M4-M5 SSI-7485-Mod-2 ROZELLE INTERCHANGE COMMUNITY COMMENT

We would like to see better urban outcomes for its 100 year lifespan

Rozelle Bay Light Rail Station – Green Bridge MOD 2 August 2019

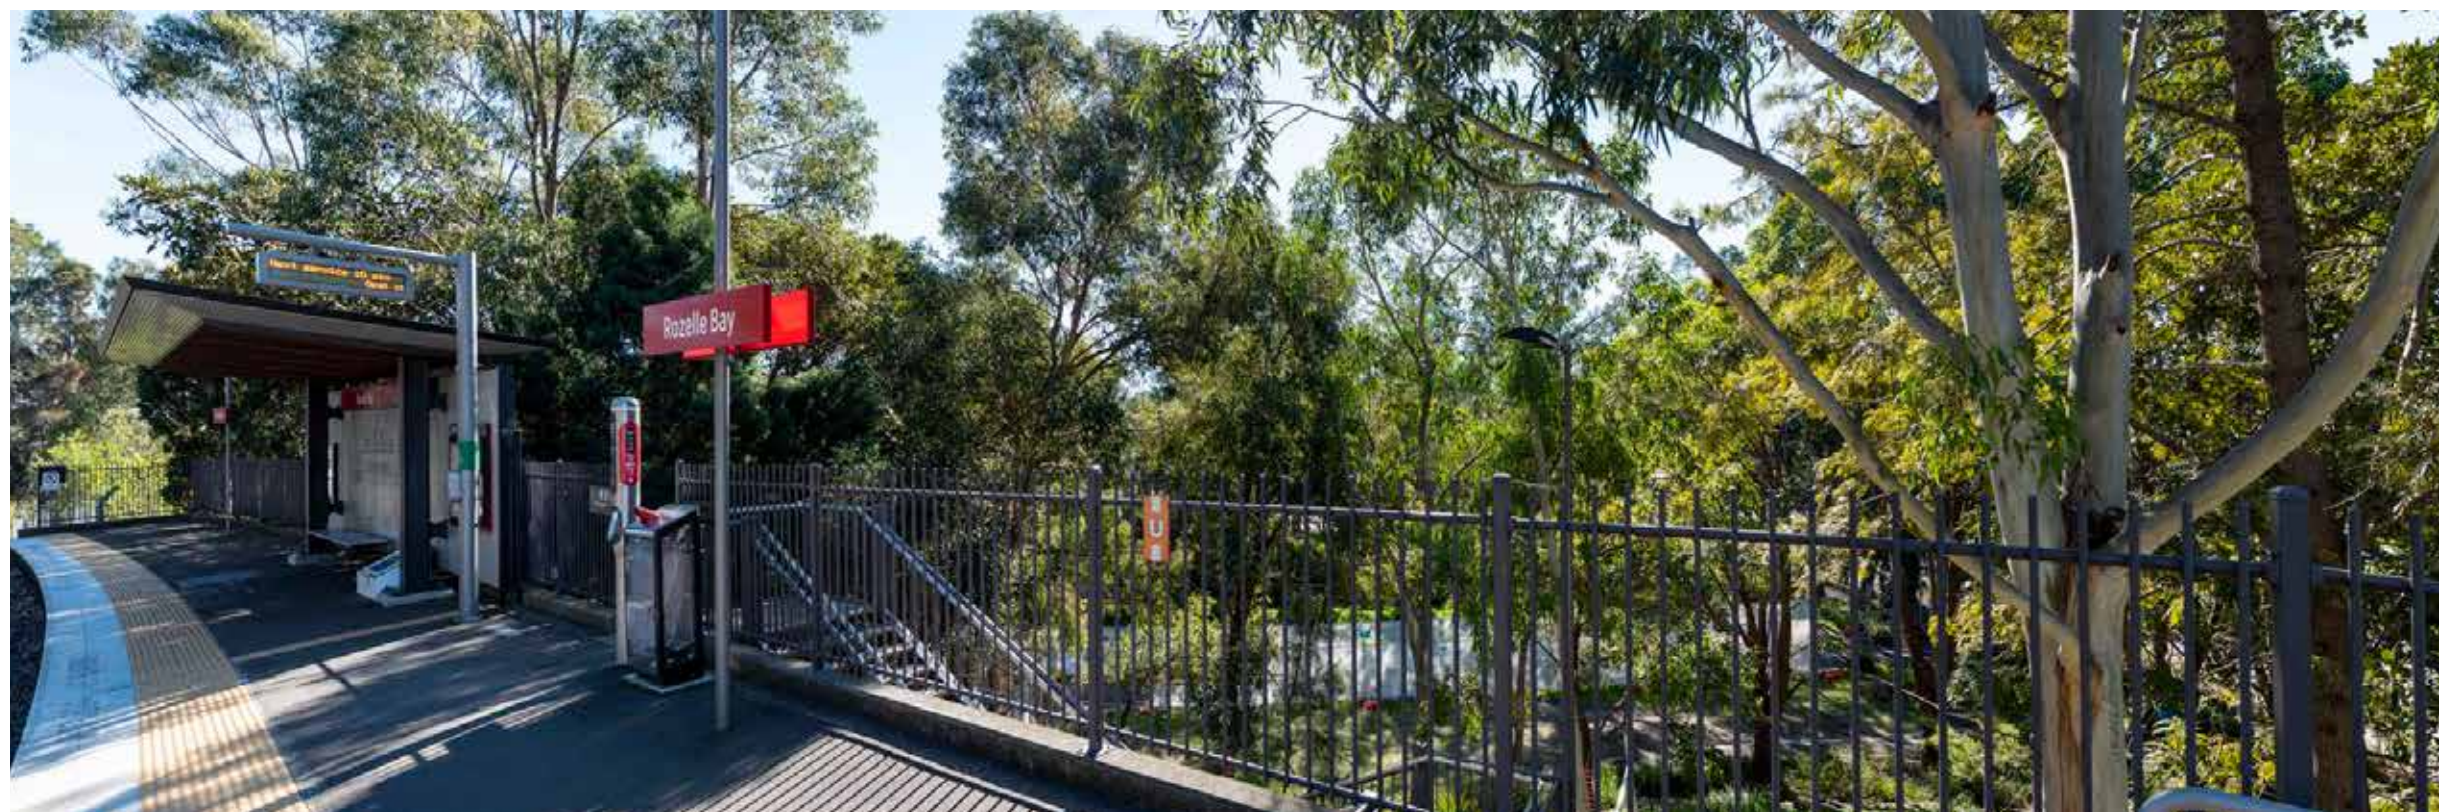
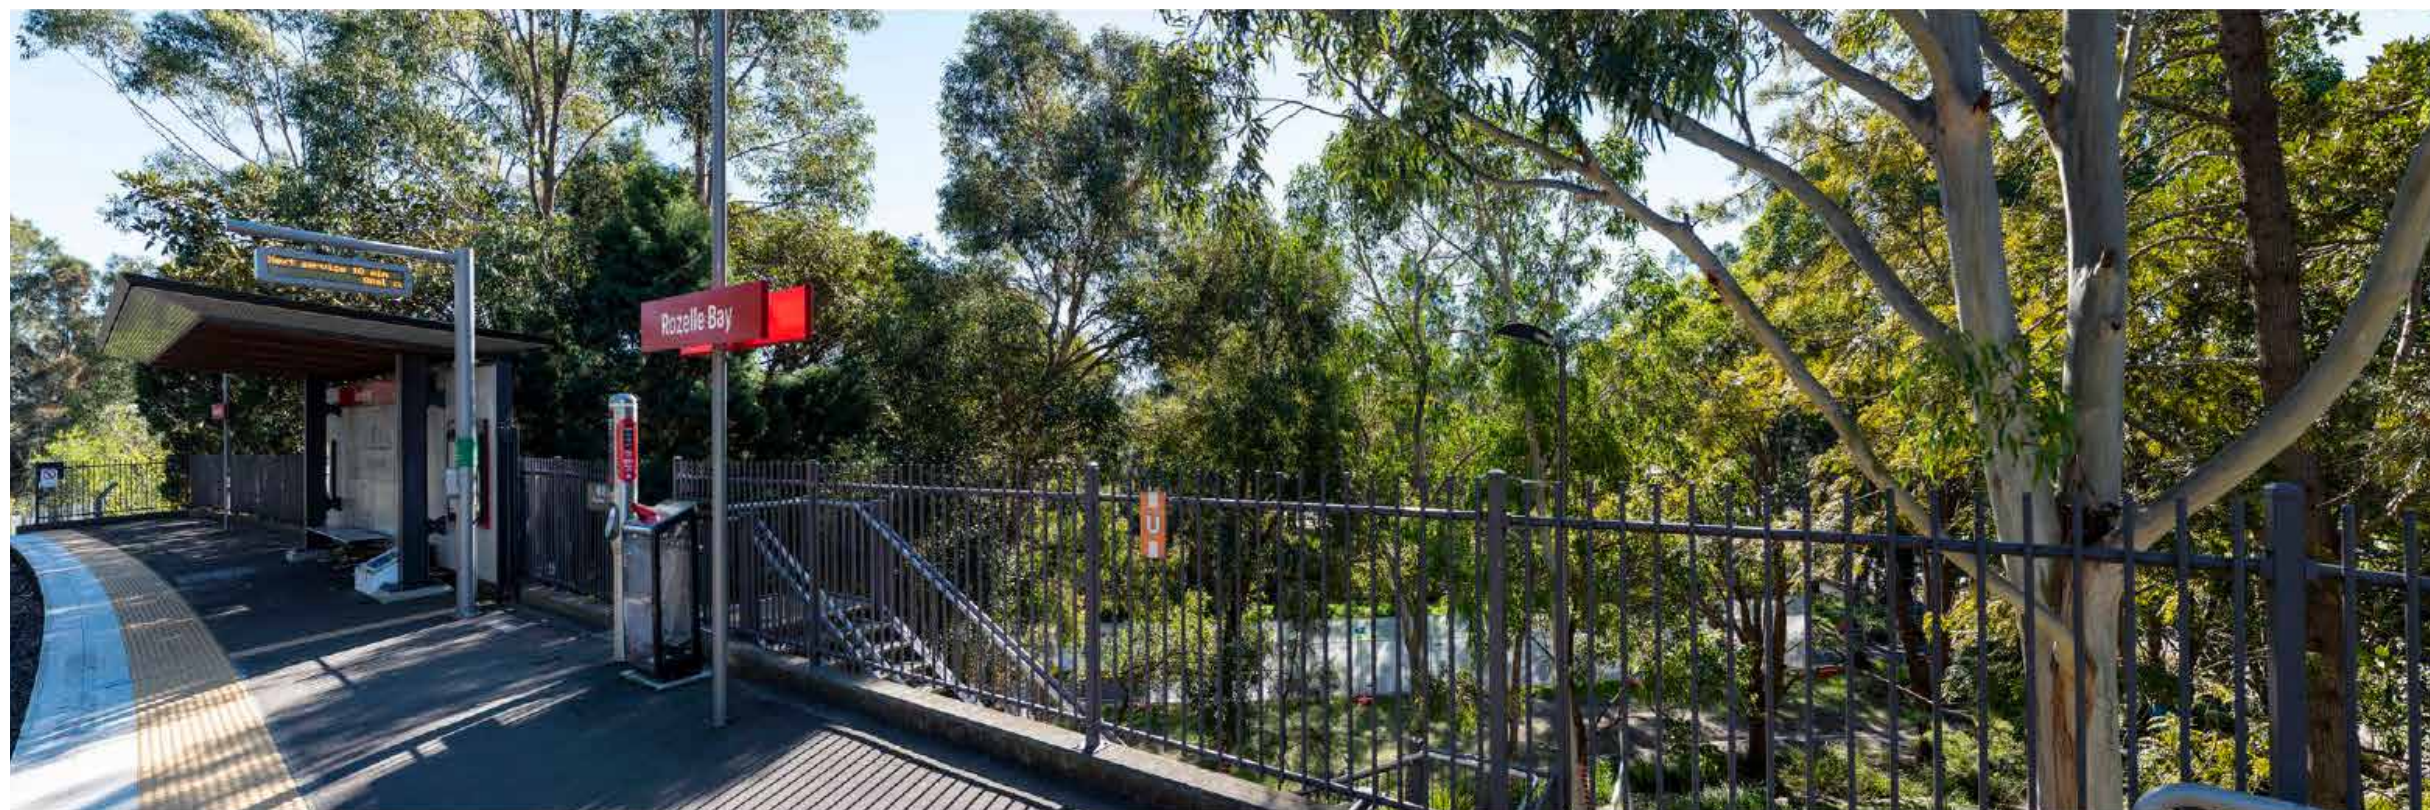
Green Bridge
removes edge
vegetation

Green Bridge
not very green

Overpass
blocks views
from Green
Bridge

View west bound on City West link showing visual impact of additional overpass and footbridge

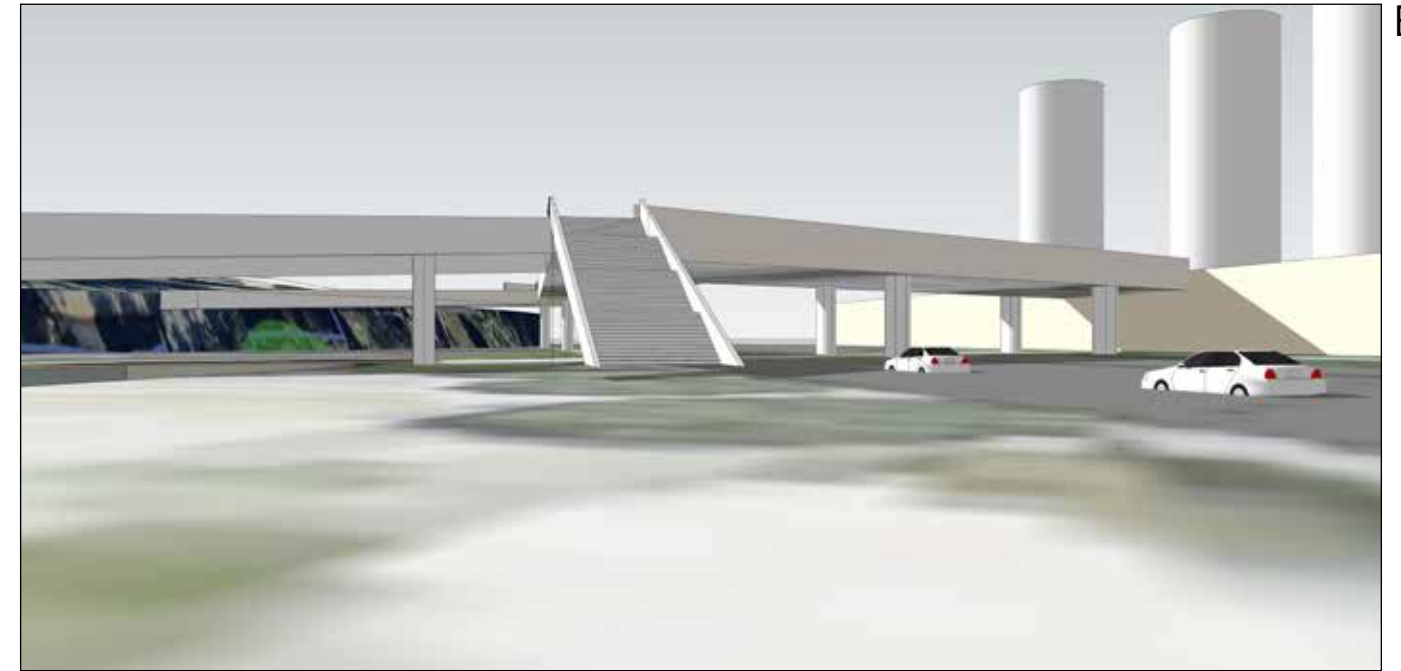
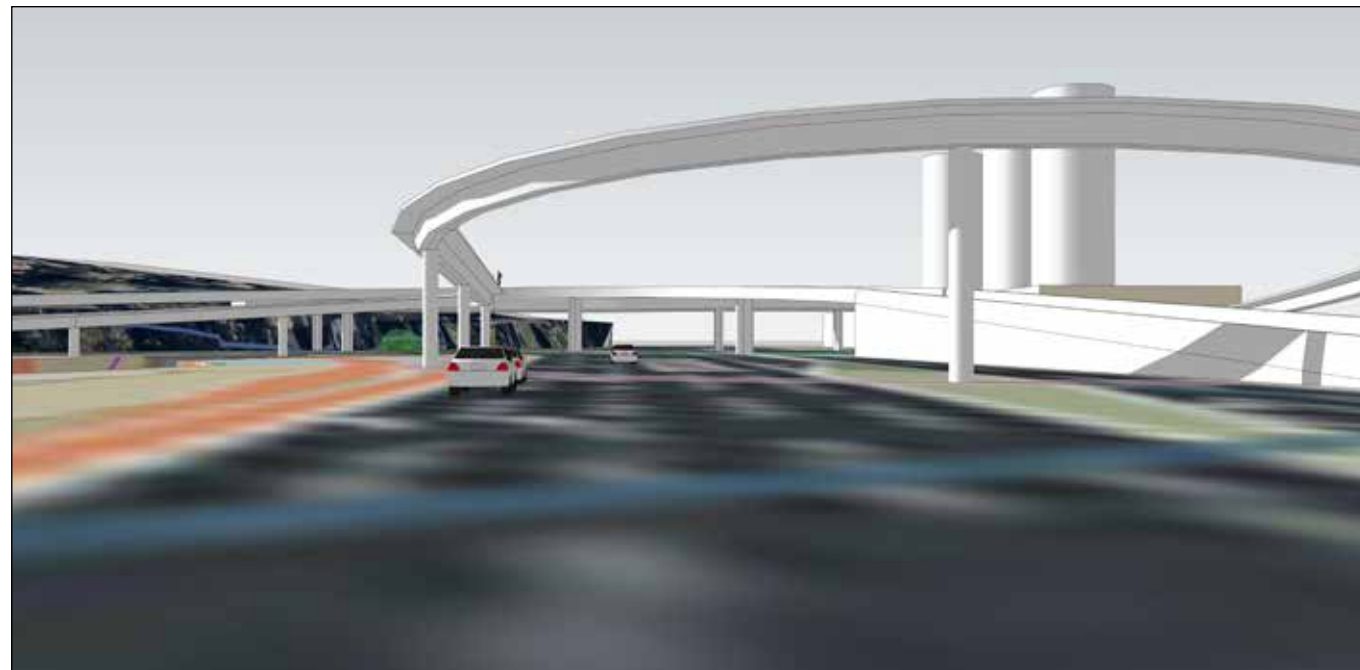
Embankment trees retained

Aerial view looking north west Illustrating complexity and lngth of new footbridge

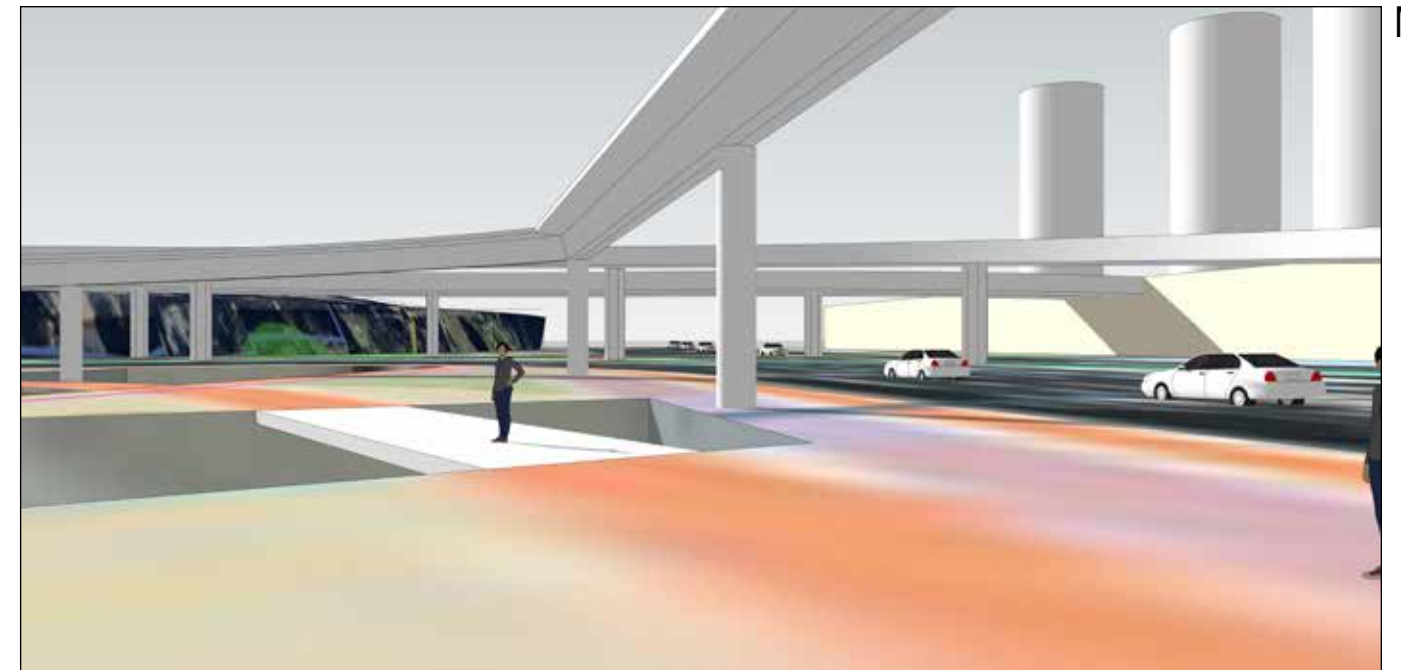
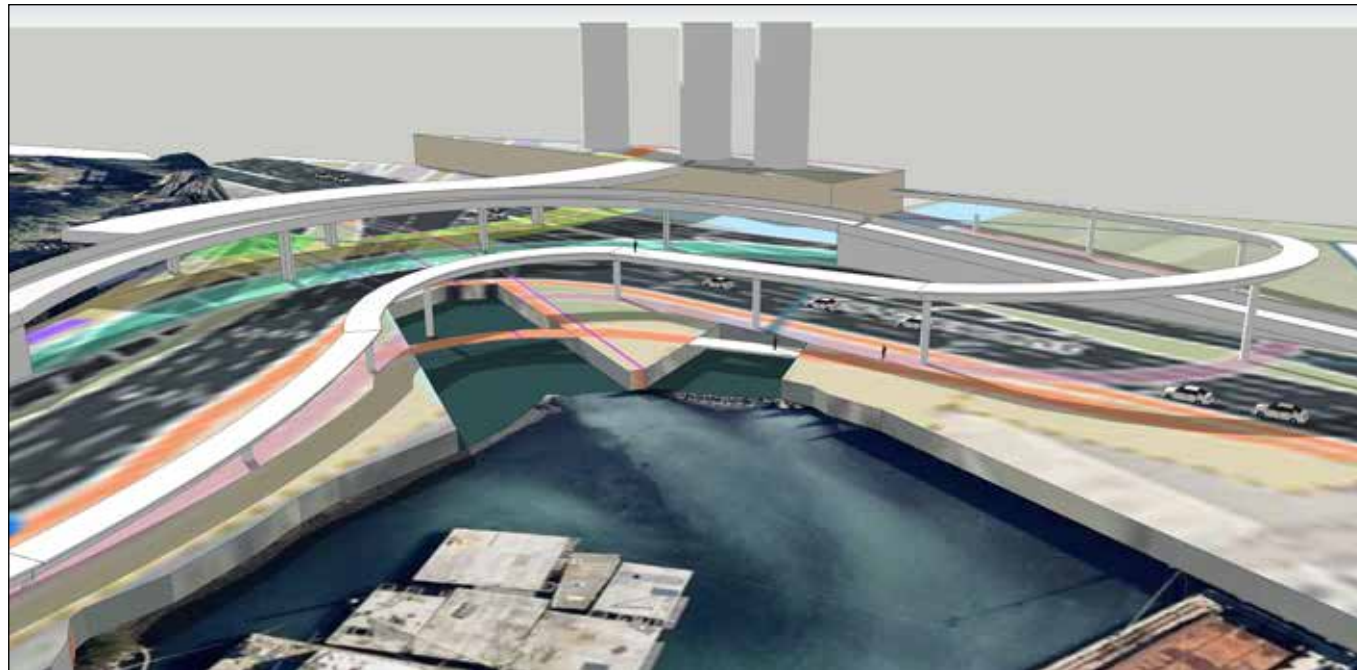
Aerial view looking east showing additional vialual impact of the overpass and additional footbridge

Proposed Slot trench in centre to short tunnel

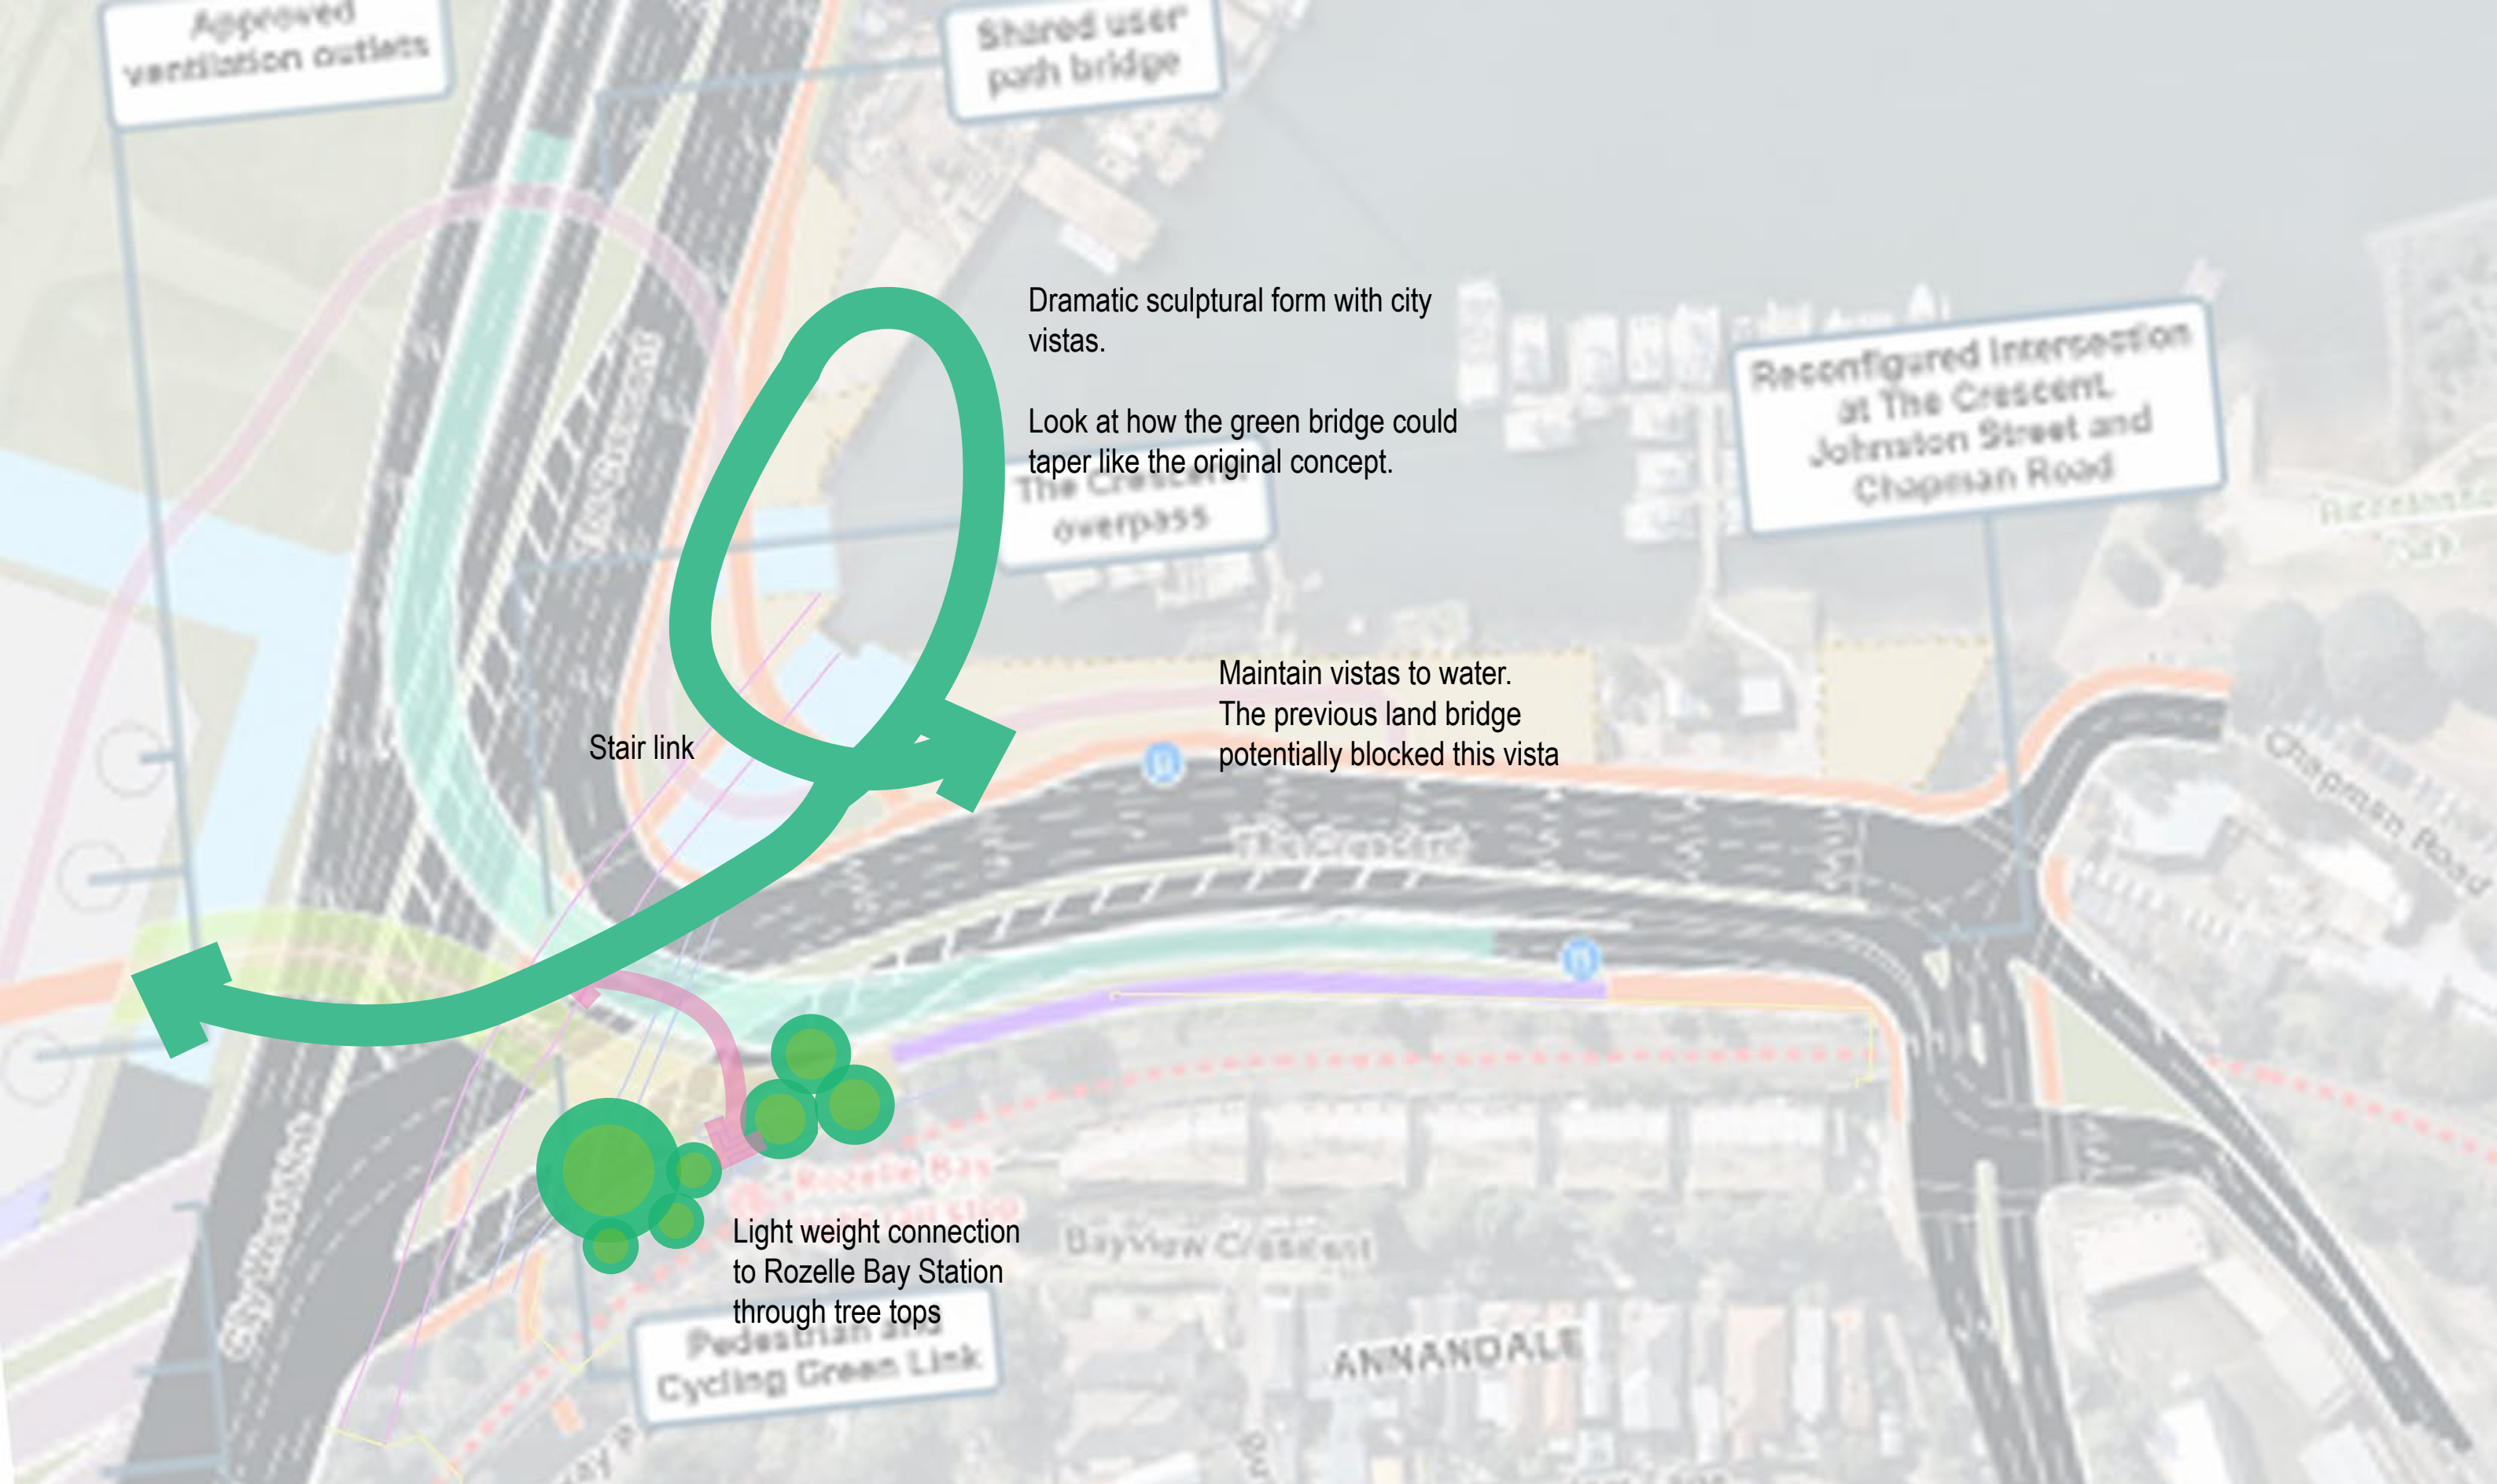
Option 2 is a better urban outcome

Allows Green bridge to connect park to park

Buruwan Park edge tree retention
